**RUIDOSO-RUIDOSO DOWNS REGIONAL WWTP
JOINT USE BOARD**

**PHASE 1A – SLUDGE HANDLING AND
ULTRAVIOLET DISINFECTION
FACILITIES – 2008**

CHANGE ORDER NO. 02

**RE: Ruidoso-Ruidoso Downs Regional WWTP – Phase 1A Construction
Change Order No. 2**

S34-101
SHEET 23

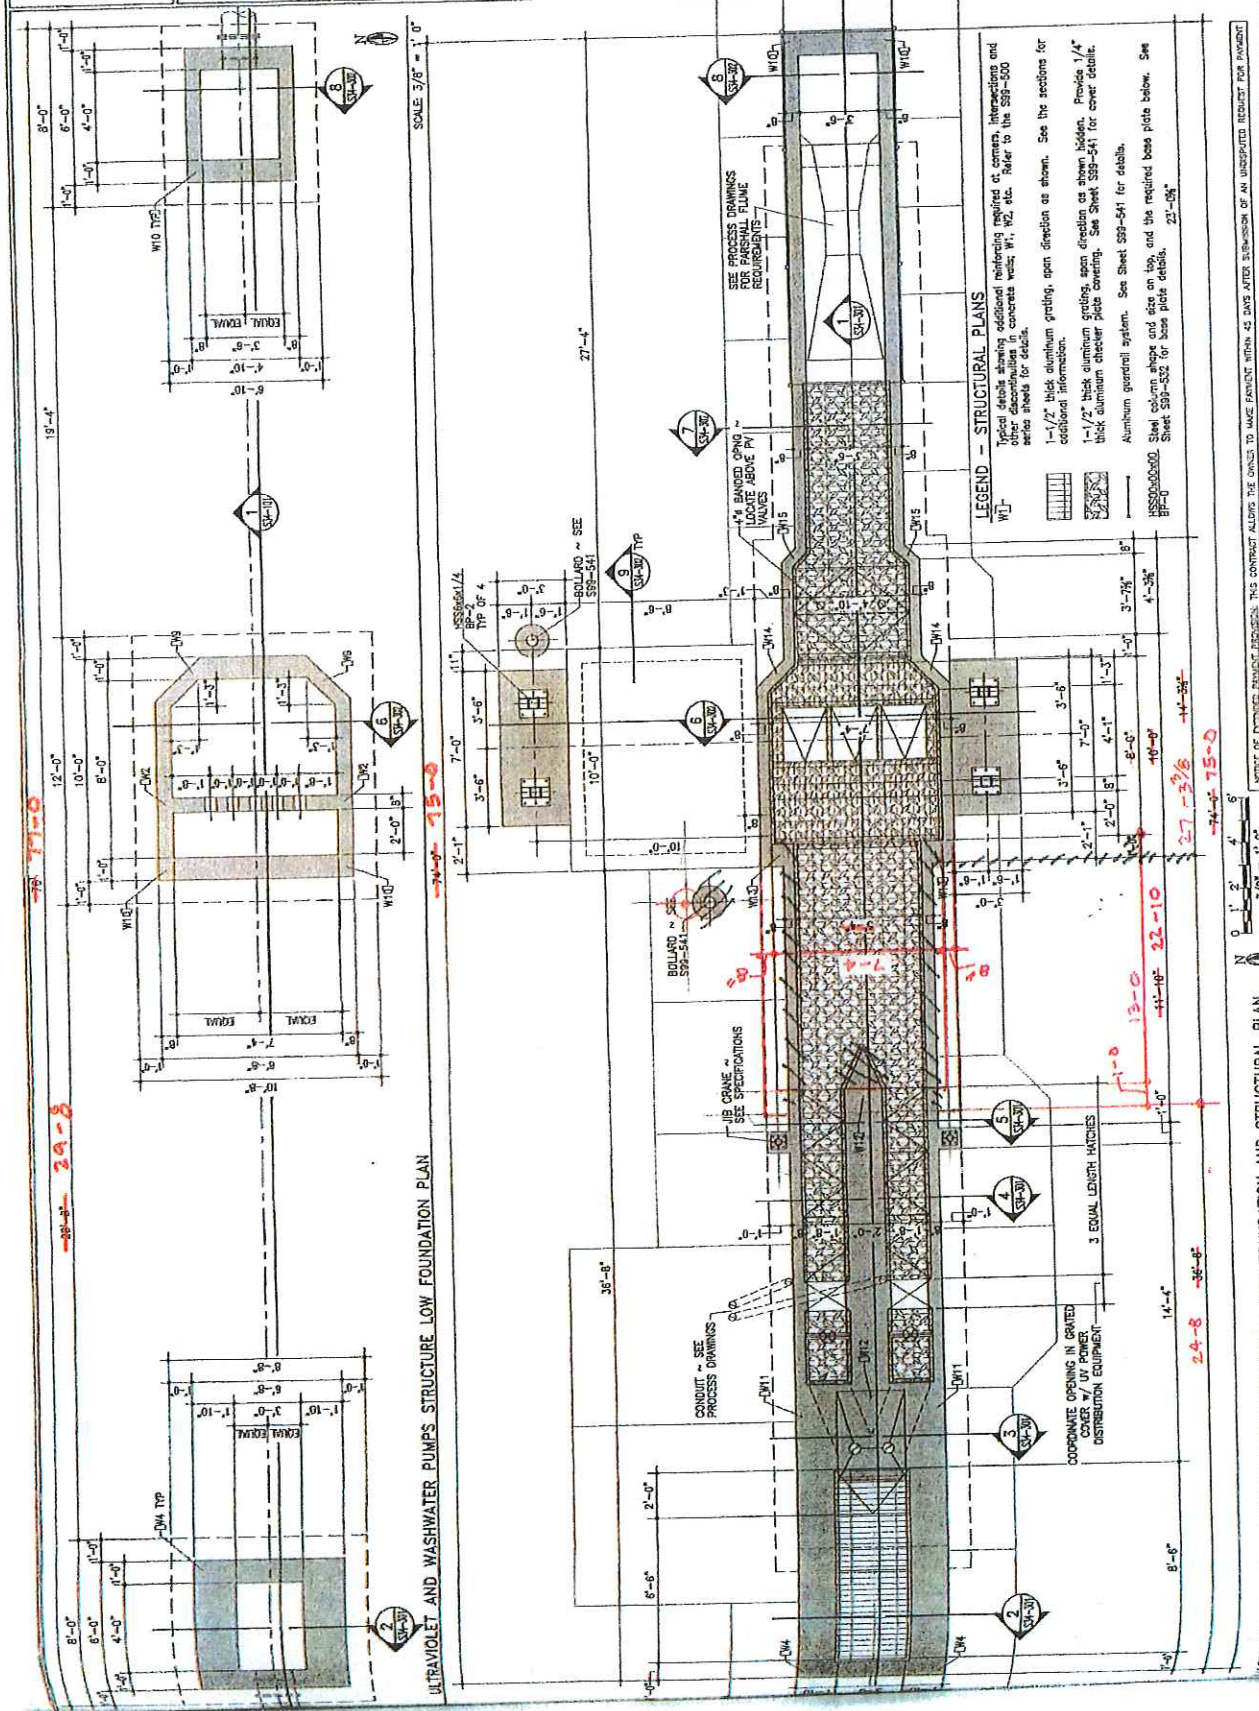
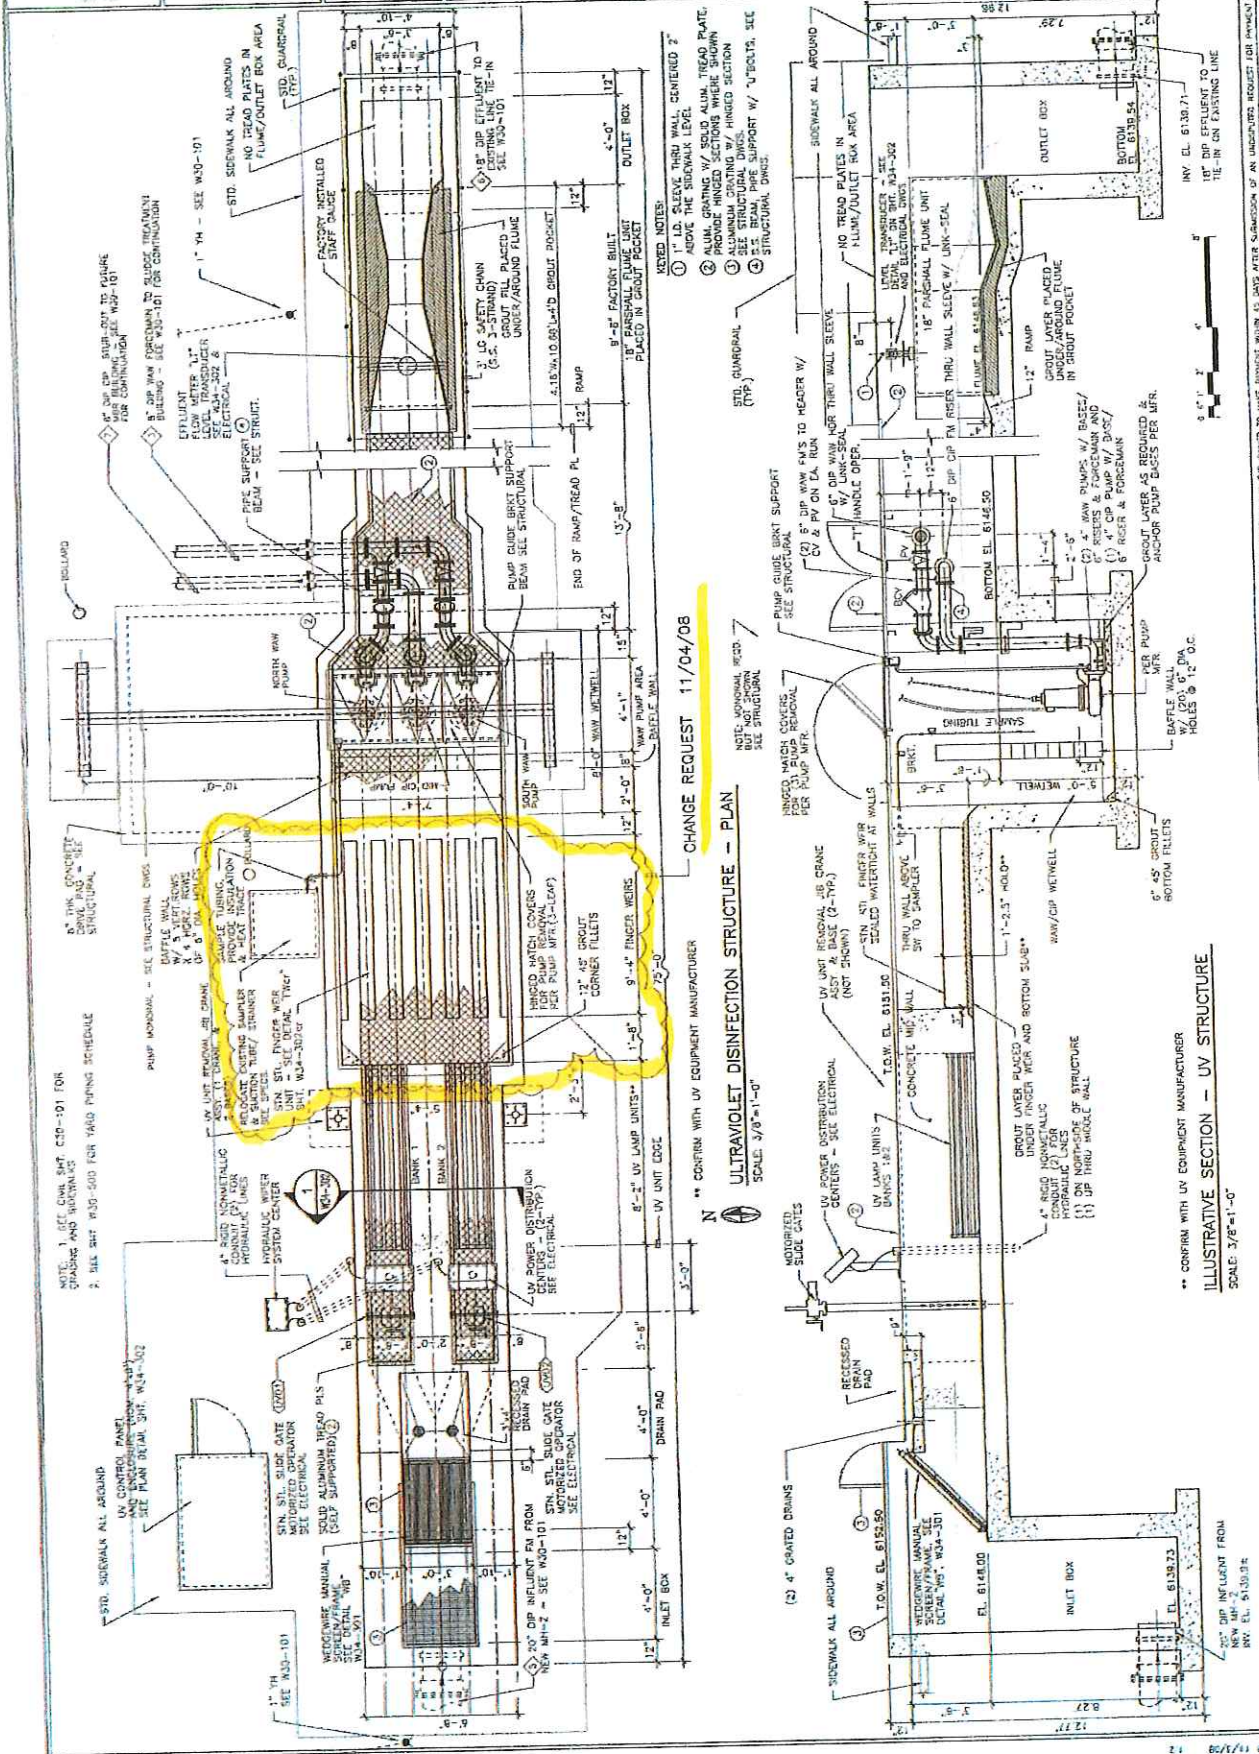
Description: **Change Request Dated 11/4/08 by Mr. A. Campos to Extend the UV Structure to allow for a longer and wider Finger Weir as shown on drawing S34-101 Redmarked.**

A. SCOPE AND JUSTIFICATION: The head requirements to submerge the UV lamps was changed by the manufacturer which resulted in a change to the finger weir design. To accommodate the increase in finger weir length, the structure was made longer and wider. This modification includes additional grating sections at a material cost of \$3,840.

I somehow doubled the additional square footage when I reviewed the drawing. I had $(7'-4") - (5'-4") \times 13'-0" = 26$ sq. ft. For some reason then I doubled it to 52 sq. ft., sorry.

Looks like the 26 sq. feet plus 4 sq. feet = 30 sq. ft. Revised number should be \$3,840.00.

W34-302cr

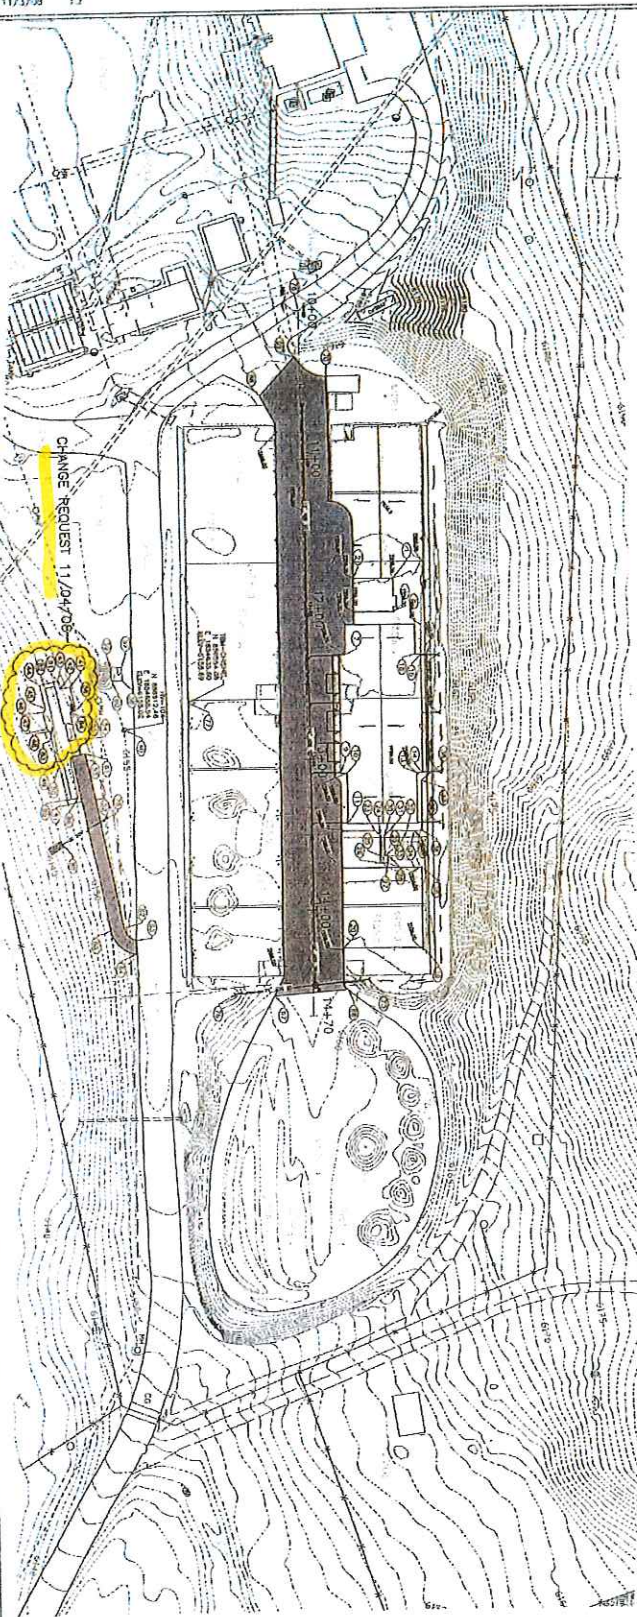
ULTRAVIOLET DISINFECTION
EQUIPMENT - MISCELLANEOUS DETAILS II
CHANGE REQUEST 11/04/08
PHASE 1A - SLUDGE HANDLING AND ULTRAVIOLET DISINFECTION FACILITIES
RUIDOSO - RUIDOSO DOWNS REGIONAL WWTP JOINT USE BOARD
RUIDOSO - RUIDOSO DOWNS REGIONAL WWTP JOINT USE BOARD
LINCOLN COUNTY, NEW MEXICO

BCE2007-024/SF-03 02/03/2009

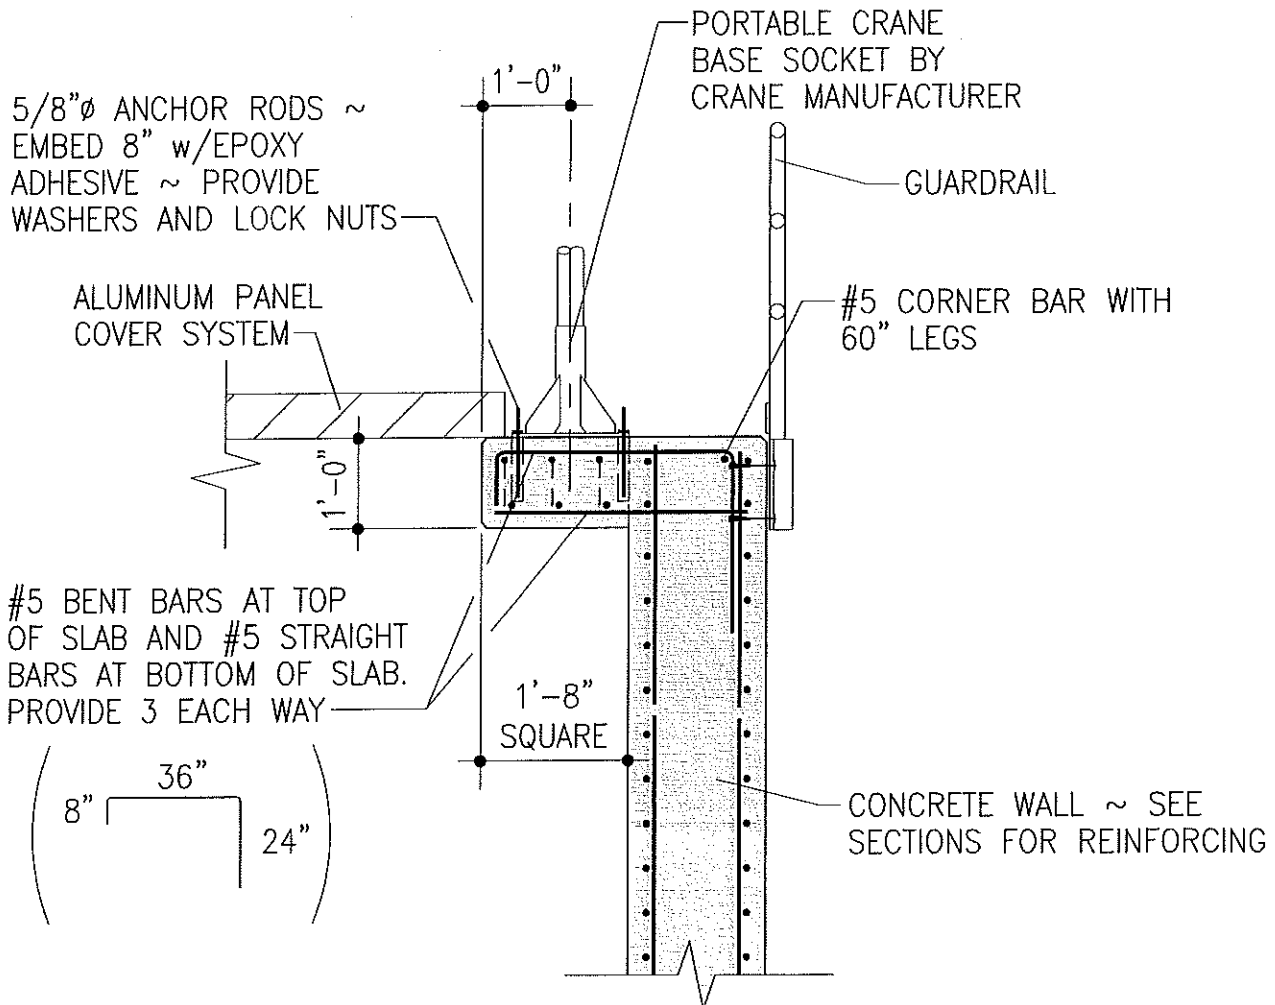
Description: **Modify UV structure to accommodate definition of the Slide Gates blockouts and reinforcement as shown on Bacchus Engineering Drawing SF-04 dated 30 January 2009.**
